Addendum 1

City of Canton, Ohio
Purchasing Department
218 Cleveland Ave. SW, 4th floor
Canton, Ohio 44702

Collection Systems Service Center Garage Addition and Administration Offices
Renovation

Revision 1:

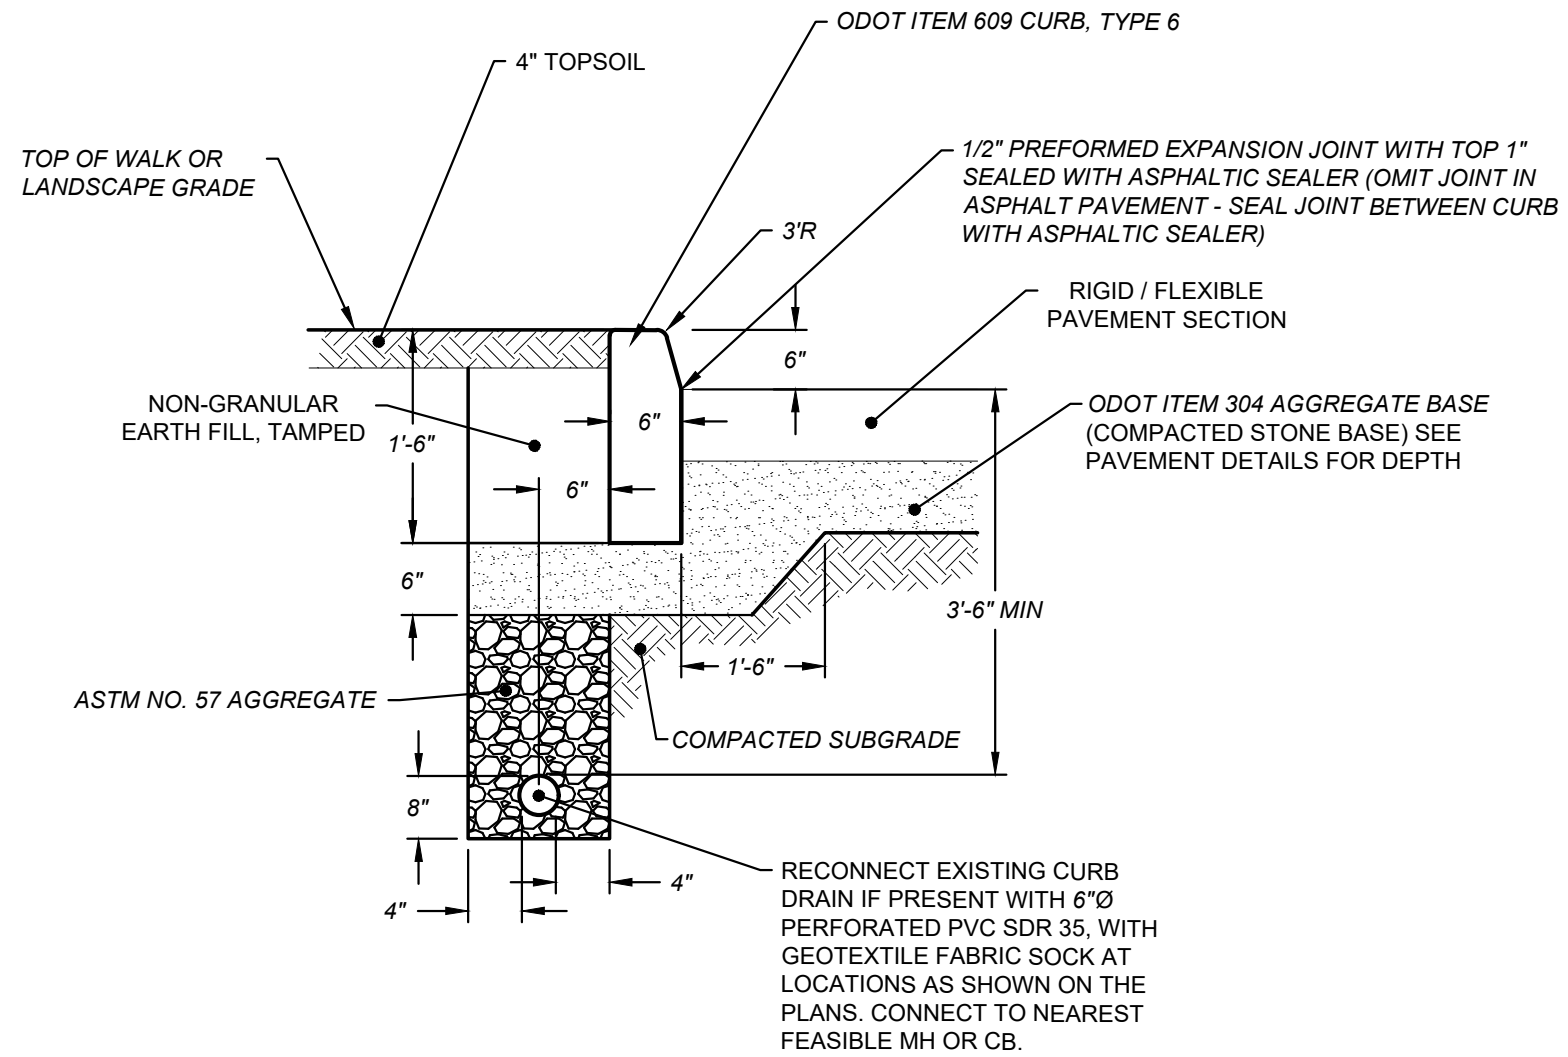
Add one (1) 2" conduit under asphalt drive/parking from gate operator location to enter building adjacent to where electric conduit is shown. Stub up inside building. This conduit will be for communication to gate operator system.

UNDERDRAIN DETAIL
SCALE: NONE

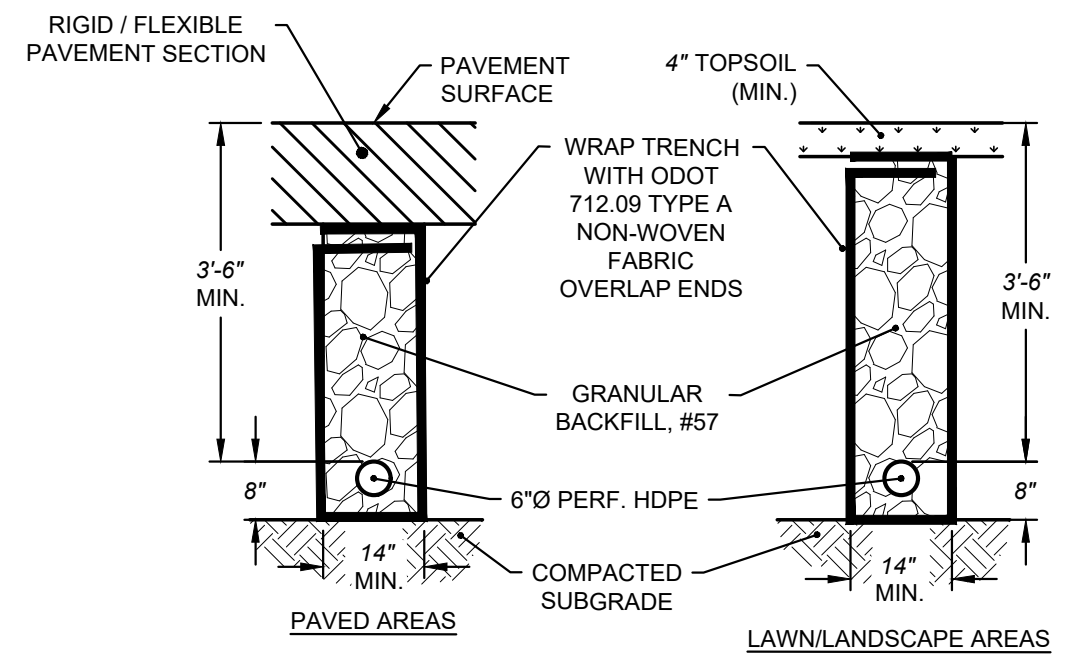
On the utility plan curb drains and finger drains are pointed out, but there is no detail provided to show the depth these need to be placed. Do you know how deep this underdrains need to be placed?

Underdrains and Curb Drains as shown on the utility plan per keynote 10 and 11 shall be installed with the top of the 6" pipe matching the crown of outlet pipe at the inlet. Detail of curb drain and underdrain is issued in this Addendum.

DWG
E-2.1

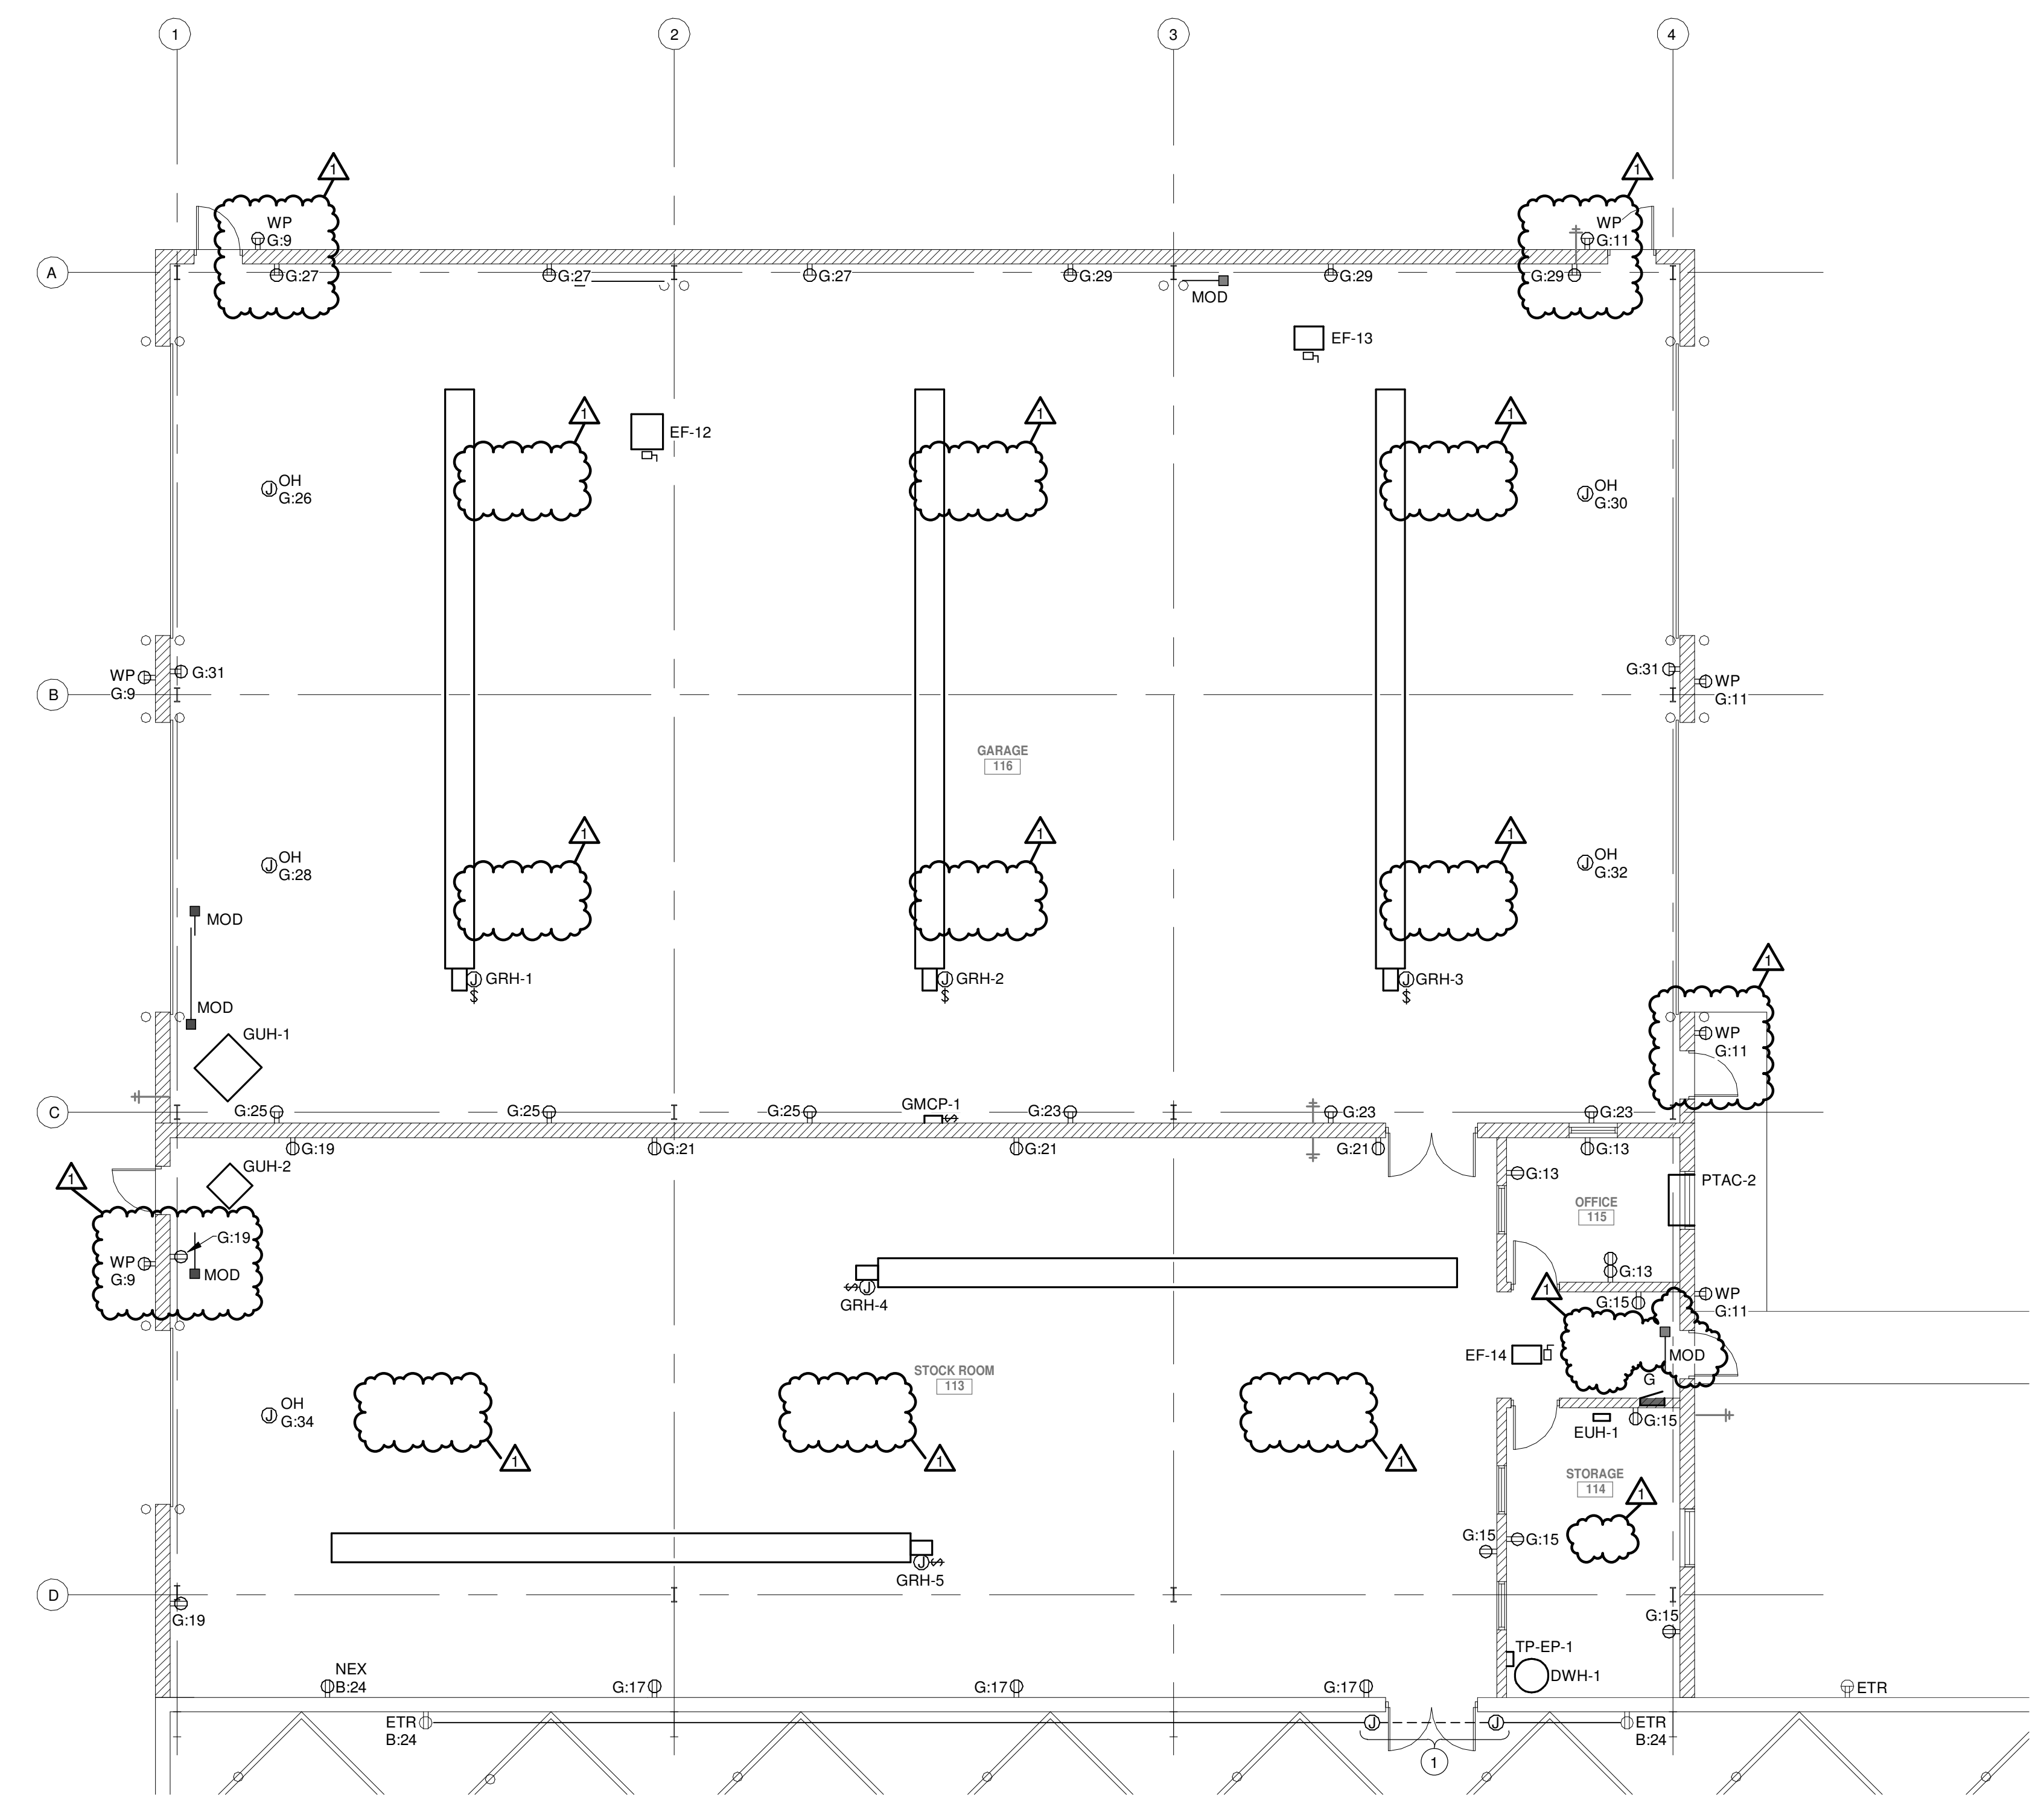
E-2.1 Removed (4) manual fire alarm pull stations, (1) local smoke detector and (10) area fire alarm A/V notification devices.
